CONFIRMATION OF FEASIBILITY

**Our Ref: CDS25007914 Pre-Connection Enquiry
The Mill, Ballinacurra, Midleton, Cork**

Uisce Éireann has reviewed the pre-connection enquiry in relation to a Water & Wastewater connection for a Multi/Mixed Use Development of 134 unit(s) at The Mill, Ballinacurra, Midleton, Cork, (the **Development**).

Figure 1

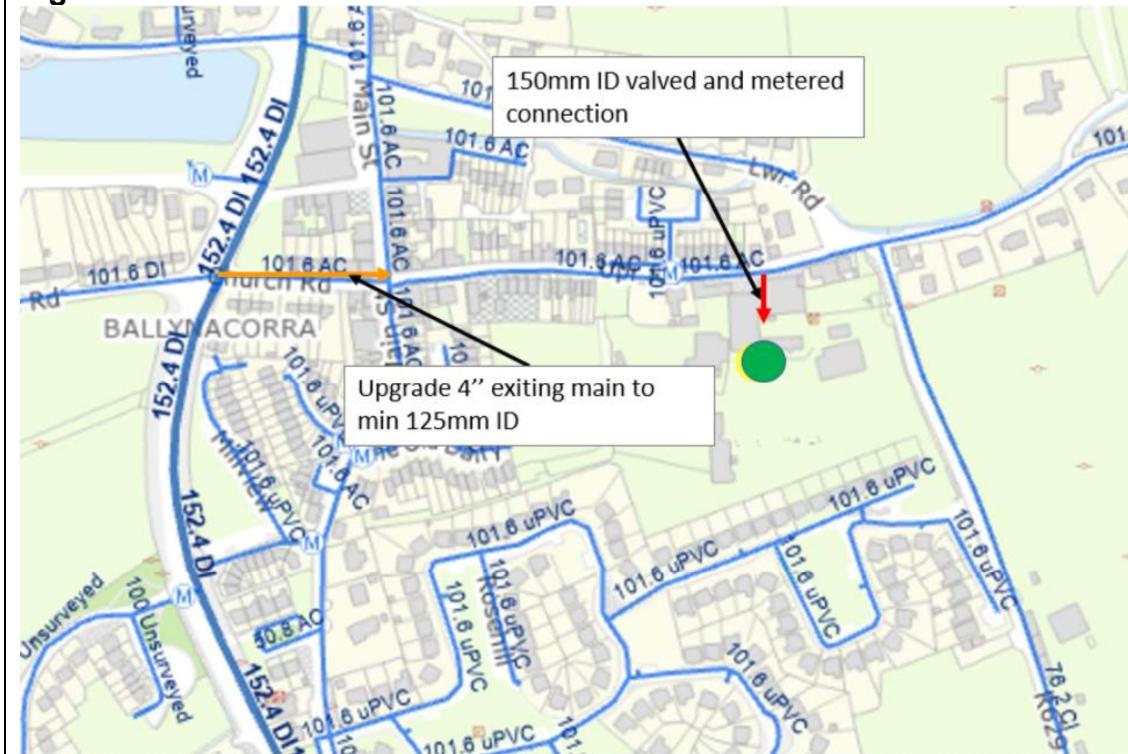
- **Water Connection**
 - Feasible Subject to upgrades
 - In order to serve the proposed development upgrades are required to the Uisce Éireann water network, The upgrades require will be approx. 110m of existing 4" main upgraded to min 125mm ID See Figure 1. Uisce Éireann currently does not have any plans to upgrade its network in this area. The cost for the provision of this network extension will give rise to a quotable charge based on the Commission for Regulation of Utilities (CRU) approved Connection Charging Policy. Any such network extension would have to be entirely funded by you. To guarantee a flow to meet the Fire Authority requirements you should provide adequate fire storage capacity within your development
